To: Stakeholders for Pacific Gas and Electric Company's 2022 Wildfire Mitigation Plan Update

DRAFT DECISION ON 2022 WILDFIRE MITIGATION PLAN UPDATE

PACIFIC GAS AND ELECTRIC COMPANY

October 2022

Figure 4.2-3: Net Change from 2021 to 2022 WMP Reporting Period ($ Thousands)

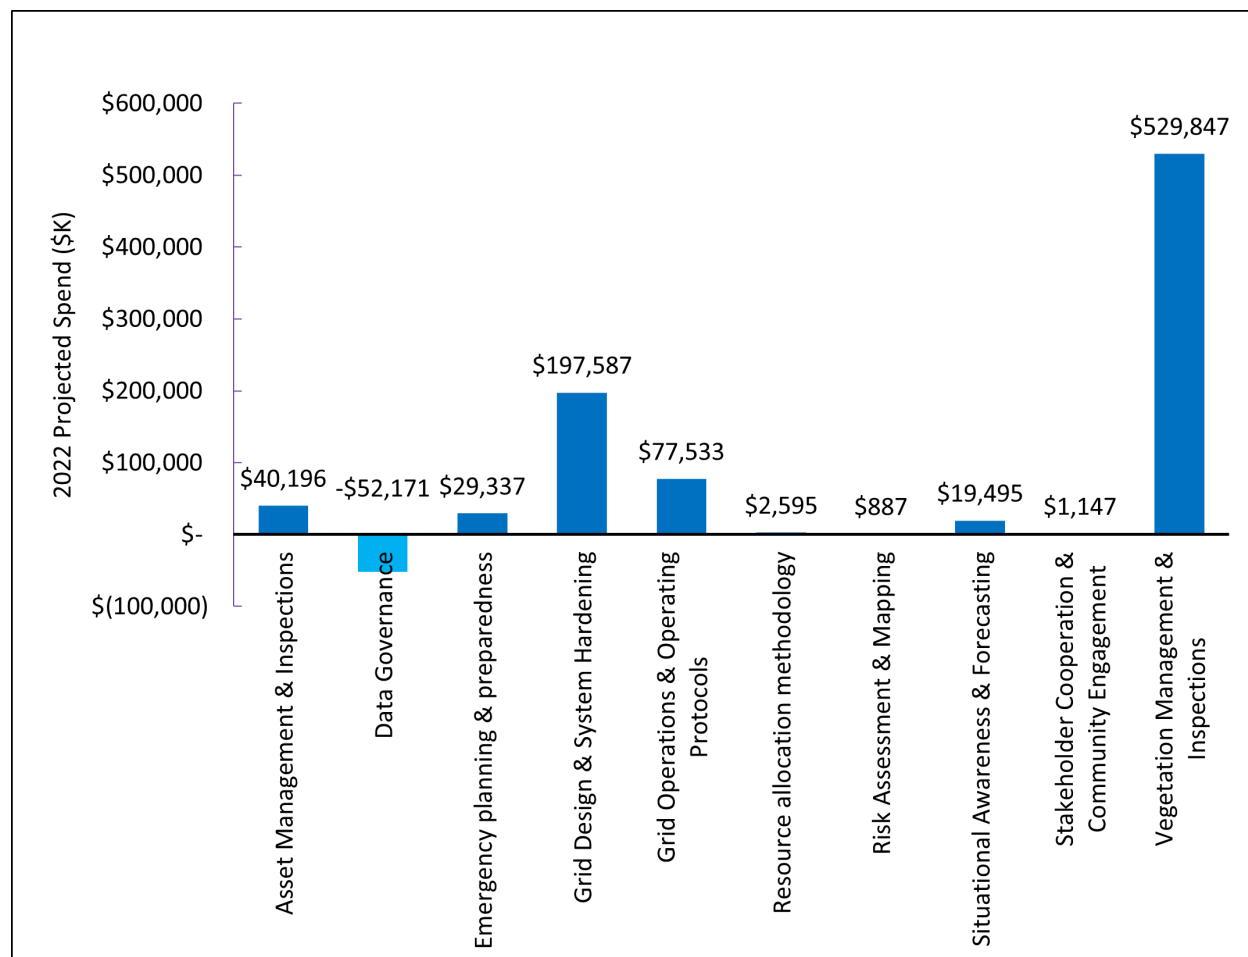
Energy Safety requested additional information about the largest changes in mitigation category spending when comparing expenditures included within PG&E's 2022 Update to expenditures projected for 2022 in PG&E's 2021 Update, as shown in Figure 4.2-3. Energy Safety asked about the following category expenditure changes:

PG&E responded that the increases in spending in the vegetation management category initiatives in the 2022 WMP are greater than the forecast in the 2021 WMP in order to account for updated estimates of work required in 2022. This included the need to address an increased volume of dead trees (attributed to the current drought impacting the Tree Mortality, Enhanced Vegetation Management (EVM), Transmission, and One Vegetation Management Programs.

PG&E responded that the grid design and system hardening increases are due to increased unit/work volume, inclusion and remapping of certain Maintenance Activity Types (MAT) to better align with 2022 WMP initiatives, and new programs and projects. In its 2021 Update, PG&E's forecast assumed more overhead hardening miles versus underground miles, while its 2022 Update forecasts more undergrounding. Underground costs per mile are higher than overhead hardening costs per mile.

Figure 4.6.1-6: PG&E Wildfire Distribution Risk Model (WDRM) V2 vs. V3 Risk Scores[96]

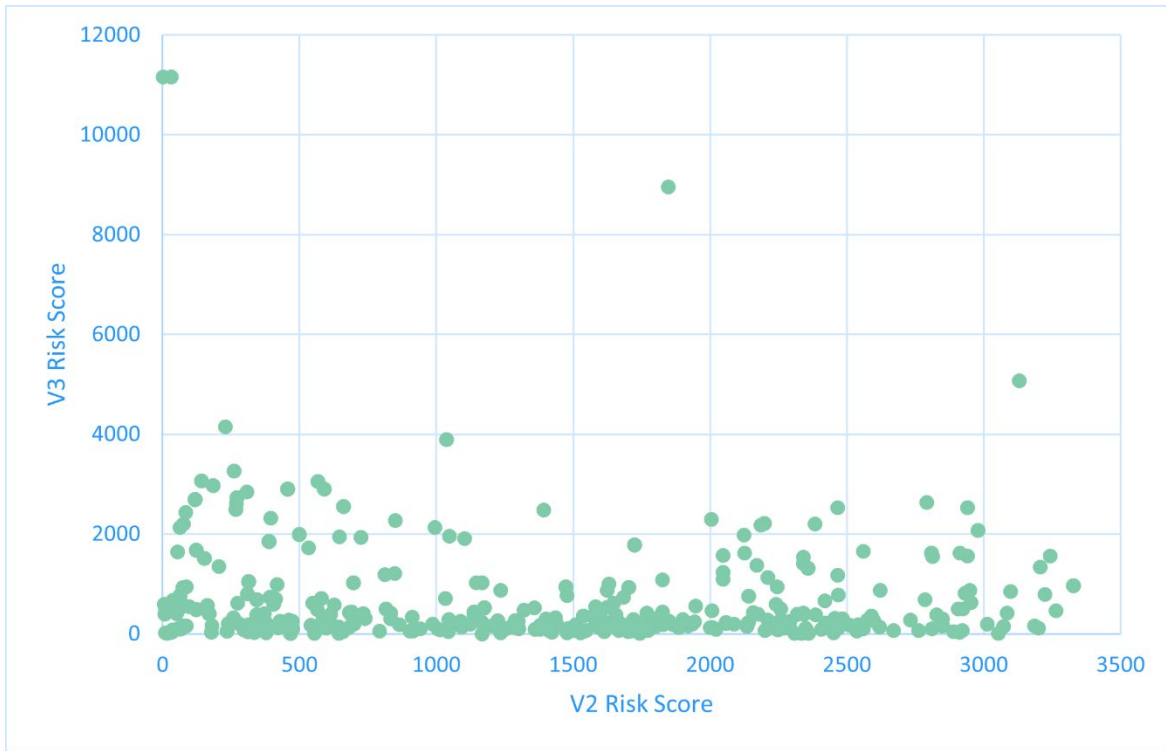
PG&E moved from Version 2 (V2) of the WDRM to Version 3 (V3). While prioritization shifts were not as drastic as those seen when adopting V2 of the WDRM, this transition did lead to a distinctive shift in prioritization. For the undergrounding projects from 2024 to 2026, no observable correlation between the V2 and V3 risk scores can be seen, as shown in Figure 4.6.1-6.[94] Additionally, when looking at all Circuit Protection Zone (CPZ)[95] risk scores, it is clear that the V2 scores lie throughout the cumulative V3 risk, with few being in the top 60 percent of cumulative risk, as shown in Figure 4.6.1-7. While Energy Safety supports improvements being made to PG&E's risk models, it is concerning that the output of risk scores continues to change in relatively drastic ways, leaving open the question of the validity not only of past models, but the current one given anticipated additional future improvements. PG&E must demonstrate an understanding of the impact of the changes made between its V2 and V3 models in order to further validate continued confidences in the risk model outputs, particularly relating to projects that may be stranded due to changes in prioritization.

Figure 4.6.4-5: Distribution Tags based on Closing Backlogged Tag Goals

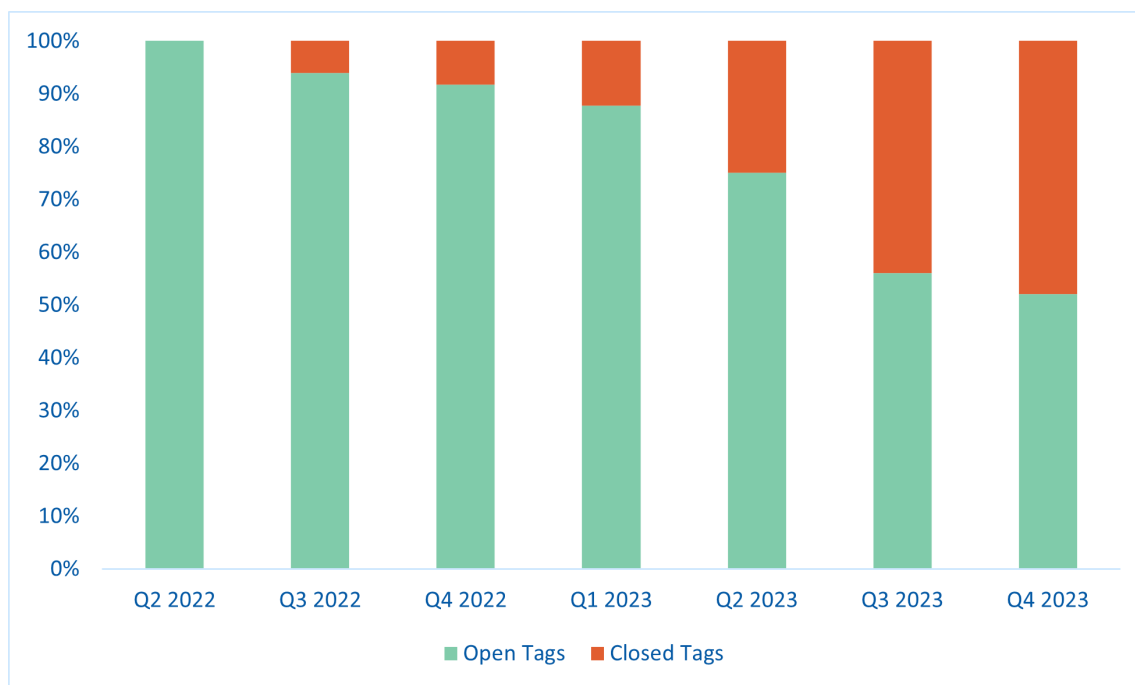
PG&E has de-escalated the critical issue RN-PG&E-22-05. PG&E provided a spreadsheet with the required information, as well as quantitative targets for 2022 and 2023. PG&E's targets for distribution are shown in further detail in Figure 4.6.4-5. It should be noted that the total number of work tags used in this figure is static based on the number of open distribution tags. Although PG&E still has a long way to go to come into compliance with GO 95 requirements and to reduce its backlog to a steady state, by committing to firm reduction targets and dispensing with the practice of continually re-starting the clock on repairs, PG&E's response to its Revision Notice is a significant step in the right direction. It should also be noted that this is not indicative of the additional tags that will be opened per quarter.

Figure 4.6.4-6: PG&E's Changes to Projected Distribution Ignitions[153]

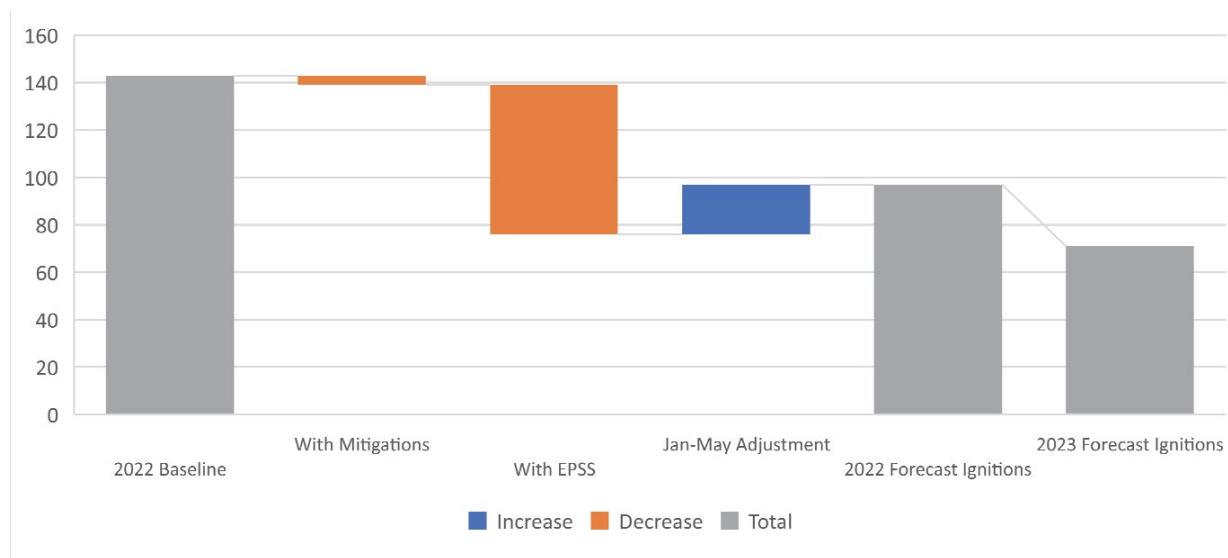
As shown in Figure 4.6.4-6, most of the decreases in the 2022 baseline ignitions are due to EPSS implementation, with minimal decrease from additional initiatives outside of EPSS. PG&E stated that, excluding EPSS, it expects ignitions to decrease by 3 percent from 2021 to 2022, and by approximately 7.4 percent from 2022 to 2023.

Figure 4.6.5-3: PG&E's Tree-related Outage Data and Trend Line[181]

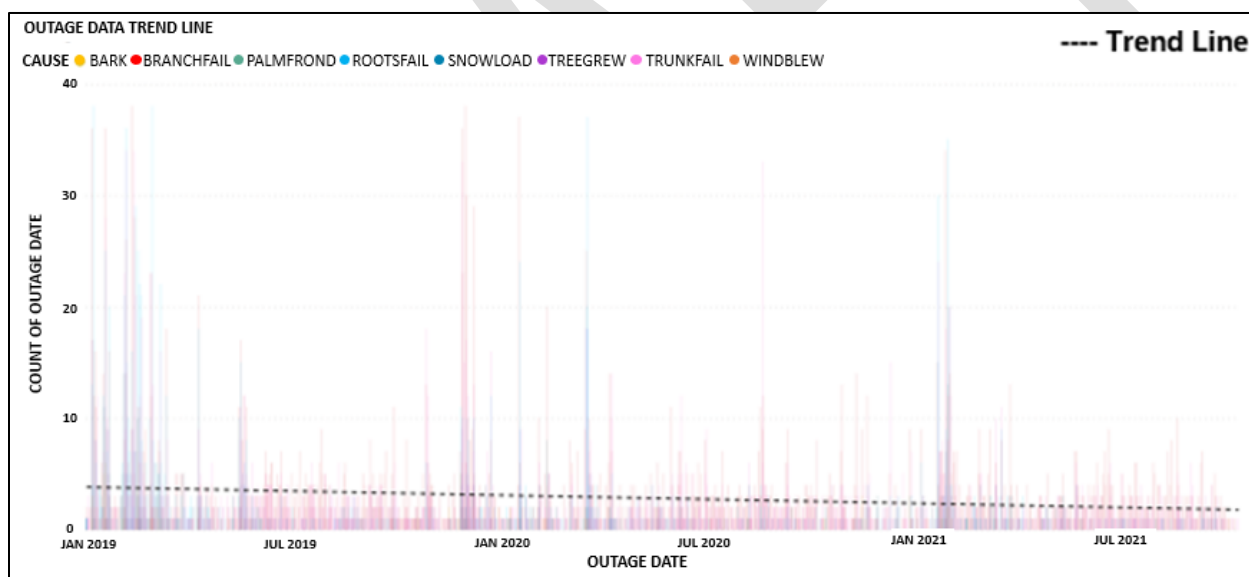
PG&E examined outage data confirmed as tree-related events and the distinct causes[179] of the outages since the inception of its EVM program in January 2019. PG&E's analysis shows a decrease in tree-related events over the three-year period (Figure 4.6.5-3). PG&E acknowledges that "this data is preliminary and the decreases in tree-related causes cannot be attributed solely to enhanced clearances without further examination."[180] Energy Safety's analysis of the data it receives on a quarterly basis from PG&E does not show any trend (decrease or increase) in the number of vegetation-caused outages and ignitions on PG&E's grid (Figure 4.6.5-4). Energy Safety's analysis does not negate PG&E's, nor does PG&E's analysis negate Energy Safety's.

Figure 4.7-5: Map of Frequently De-energized Circuits (Source: PG&E)[302]

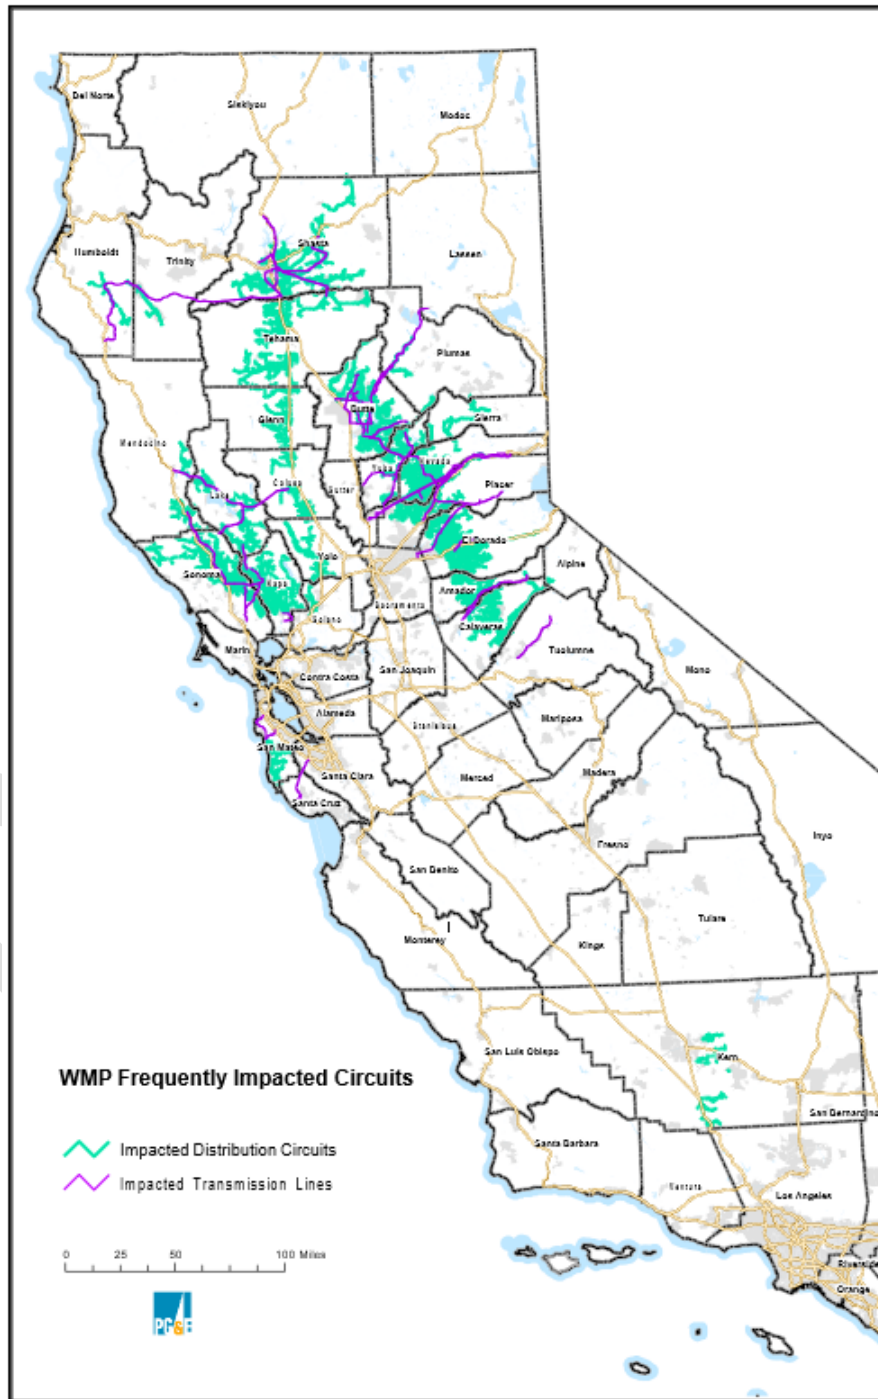
In its 2022 Update PG&E sufficiently addresses new requirements in Public Utilities Code section 8386(c)(8) to identify circuits that have frequently been de-energized (Figure 4.7-5). PG&E reports 261 frequently de-energized circuits 2018-2021,[299] and provides the following mitigations: [300]
